FUSELAGE - AVIONICS FAN SUPPORT SCREW INSPECTION

182T

18283135 thru 18283149

SEL-53-03  
Page 1 of 5

Figure 1. Fan Support Assembly Installation (Sheet 1)

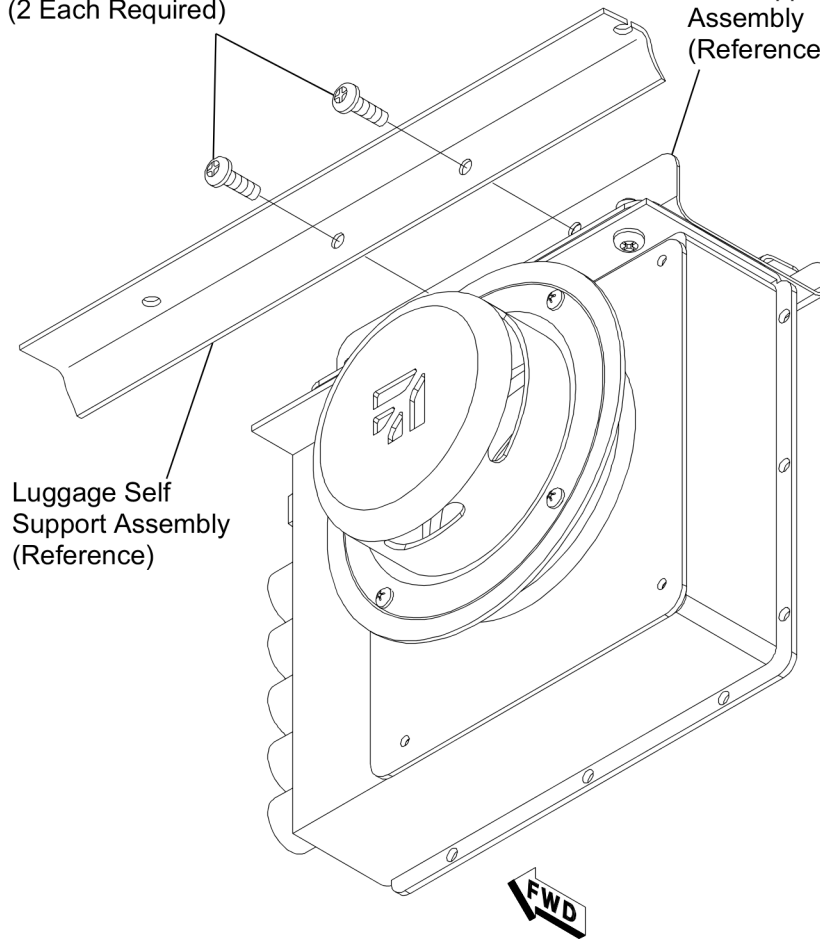
3. (Refer to Figure 1, Sheet 1.) Do an inspection of the screws in the aft avionics cooling fan support assembly as follows:
  - A. If the screws are installed, go to Step 4.

- B. If the screws are not installed, then do as follows:
    - (1) Remove the remote avionics cooling fan. (Refer to the Model 182 (Series 1997 And On) Maintenance Manual, Chapter 21, Avionics Cooling - Maintenance Practices.)

- (2) Match drill the two 0.193 inch diameter holes of the fan support assembly into the luggage support assembly.
    - (3) Apply U074093 Color Chemical Film Treatment to the areas that were drilled. (Refer to the Model 182 (Series 1997 and On) Maintenance Manual, Chapter 20, Interior/Exterior Finish - Cleaning/Painting.)

- (4) Apply K000574 Corrosion Resistant Primer to the areas that were drilled. (Refer to the Model 182 (Series 1997 and On) Maintenance Manual, Chapter 20, Interior/Exterior Finish - Cleaning/Painting.)

- (5) Install two MS35206-245 Screws to attach the fan support assembly to the luggage self support assembly.
  - (6) Install the remote avionics cooling fan. (Refer to the Model 182 (Series 1997 And On) Maintenance Manual, Chapter 21, Avionics Cooling - Maintenance Practices.)
4. Install the aft baggage upholstery panel. (Refer to the Model 182 (Series 1997 And On) Maintenance Manual, Chapter 25, Interior Upholstery - Maintenance Practices.)
5. Remove the maintenance warning tags and connect the airplane battery.
6. Make an entry in the airplane logbook that states compliance and method of compliance with this service document.

0.193 Inch-Diameter Hole  
MS35206-245  
Screw  
(2 Each Required)
